## Response to April 23, 2019 Comments

### Comment Set #1

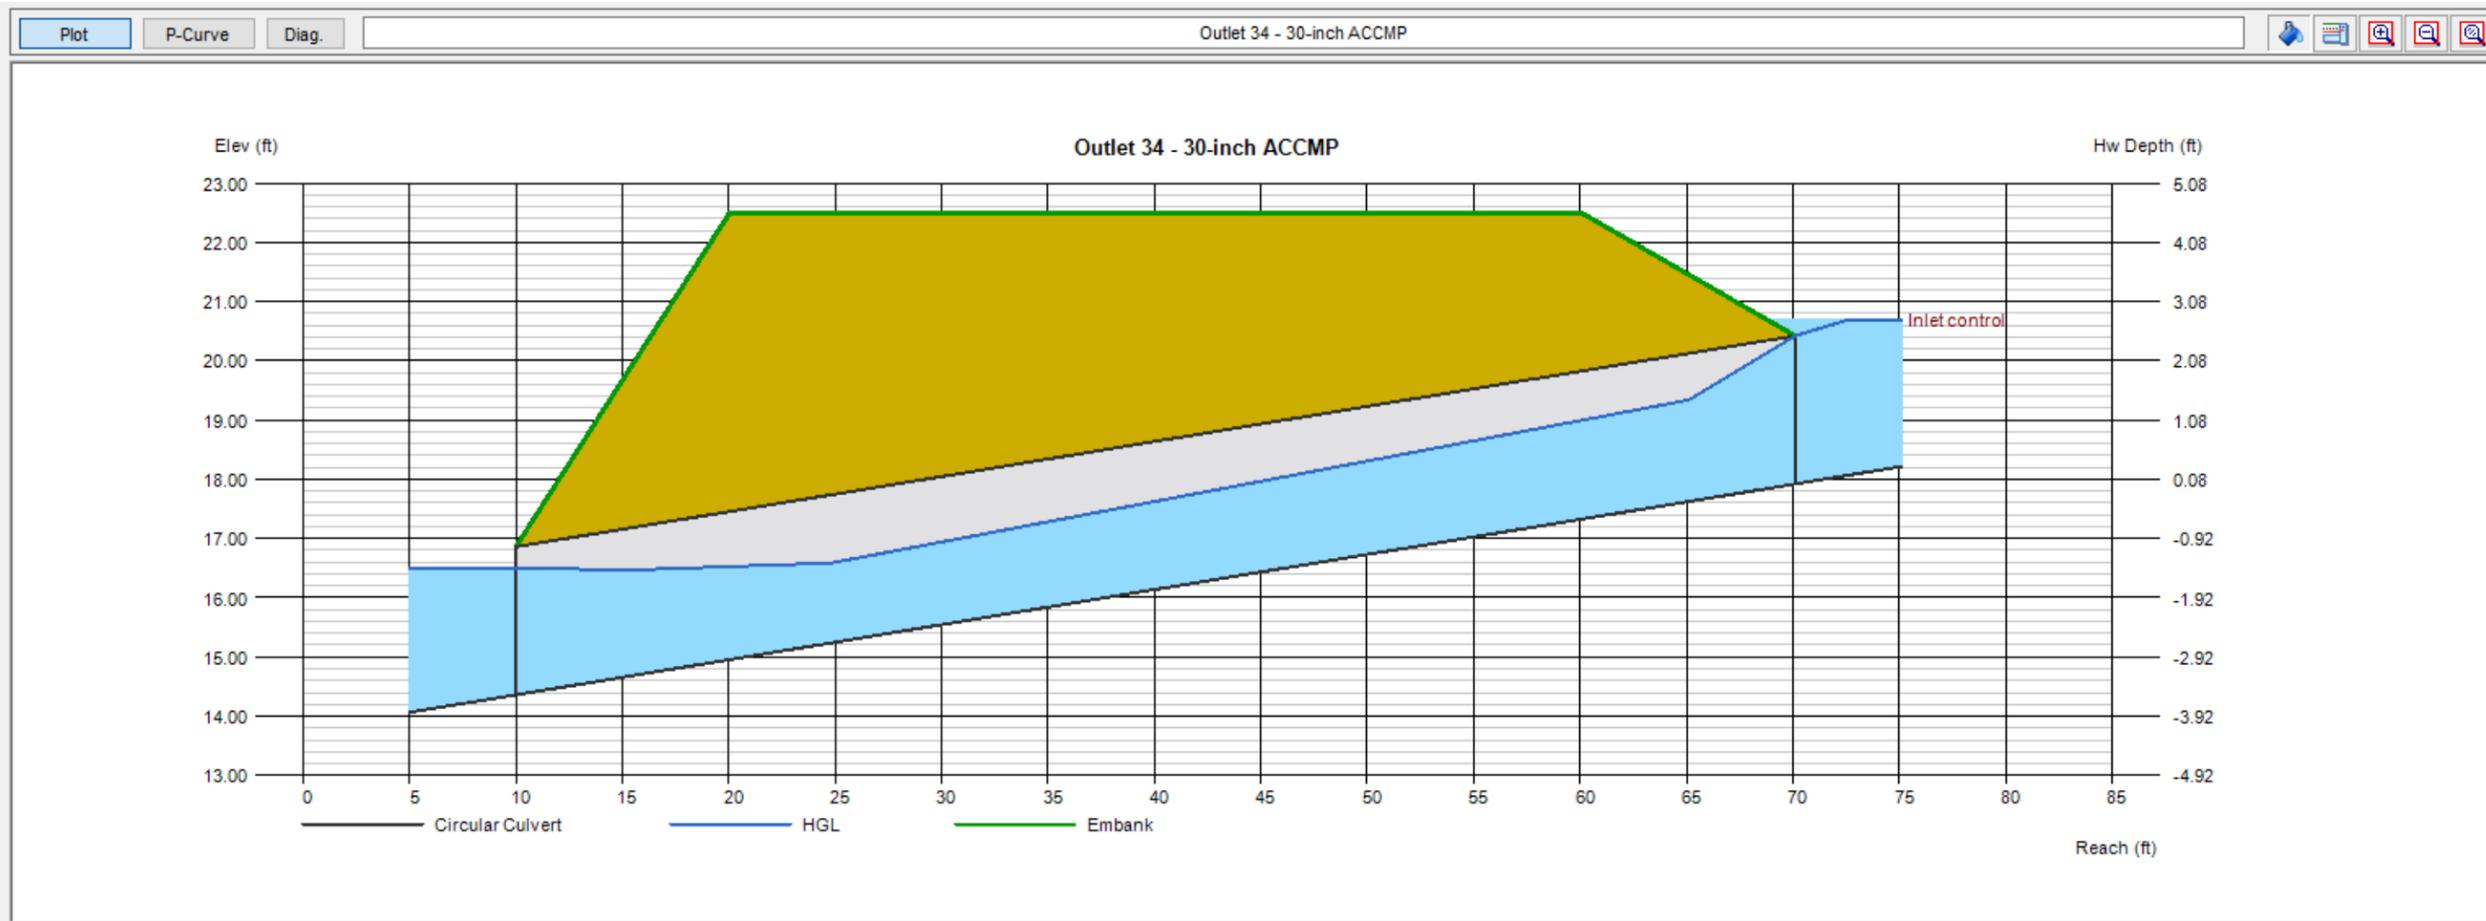
5. The Existing & Proposed Watershed Results table on Page 5 indicate that there is an increase in peak flow rate at existing outlet #34. Please confirm that the existing 30" ACCMP downstream of this outlet can safely convey the increased flows.

*4/23/19 BL Response: Please provide calculations.*

**4/25/19 Response: Attached are the calculations for the 30" ACCMP.**

25-YEAR STORM PROPOSED DISCHARGE RATE Q25=26.7 CFS
